# PERMIT

SEWAGE DISPOSAL SYSTEM

ADDRESS Town & Country Blvd., Ellicott City, Md.

PROPERTY OWNER Mrs. Joan Udoff (Enterprise Motors West)

INDICATE NORTH. - NAME ADJOINING ROADWAY AS BASE LINE.

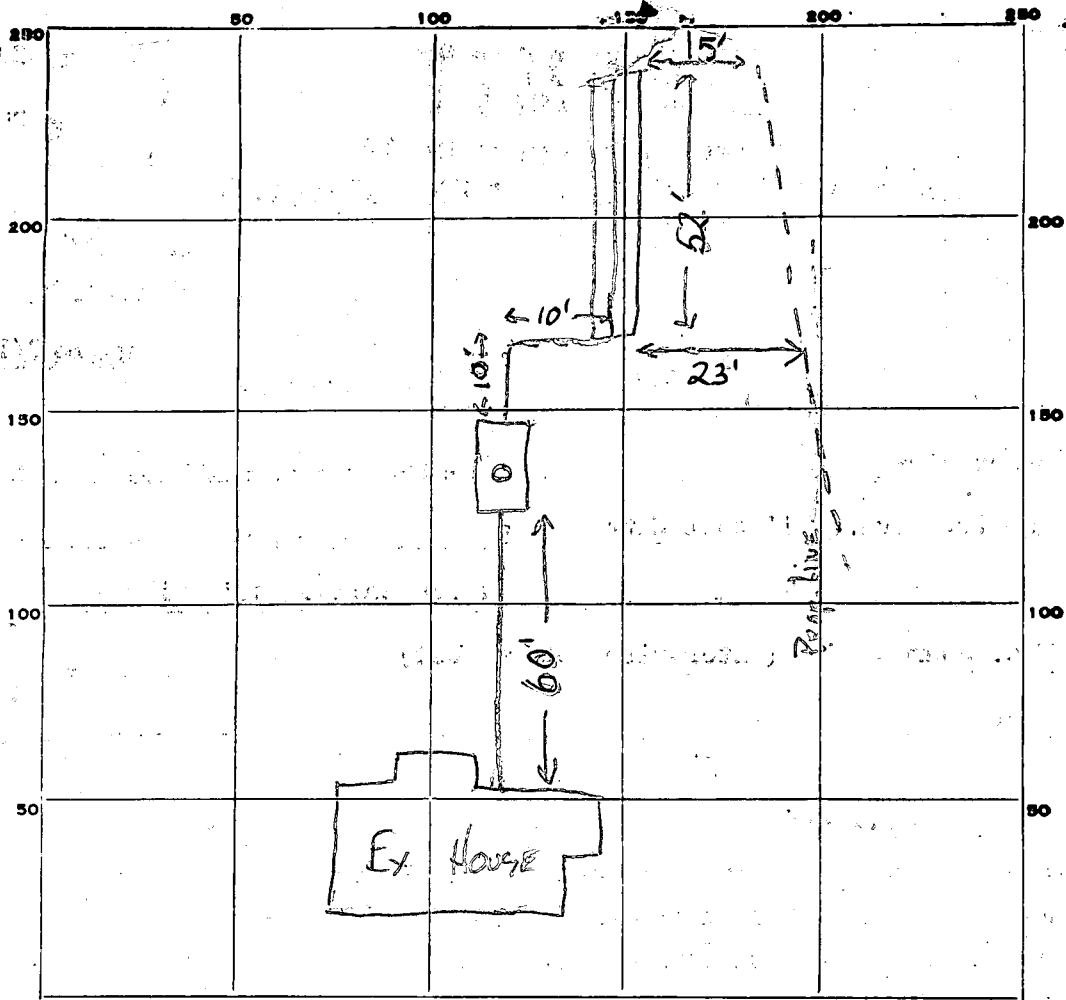
REPAIR-CALL FOR INSPECTION WHEN GROUND IS OPENED UP SO SANITARIAN CAN RECOMMEND

REPAIR. - DEEP DITCH - 2 FT WIDE 52 FT LONG, 11-12

FT DEEP WITH 7 FT OF STONE

COVER NO WORK UNTIL INSPECTED AND APPROVED. OF OLD TANK & RUN TOWARD THE BACK OF LOT

NOTE: IF TRENCH IS USED CALL FOR INSPECTION BEFORE PLACING GRAVEL IN TRENCH. NEW 1000 GAL TANK NEEDED

REMARKS 2/22/80 - SEE ATTACHED SHEET 7 4/9/80 NOT ready. J & SK  
4-9-80 - 1 TRENCH 12' DEEP. 52' LENGTH, OK TO add GRAVEL SK&JS  
4/10/80 OK to cover all work. J & SK

P 30524  
A REPAIR

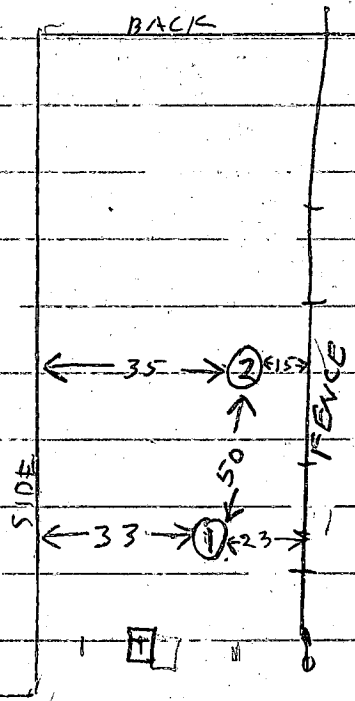
REMARKS BUSTY LEAKY METAL TANK [T] FOUND  
CITY WATER
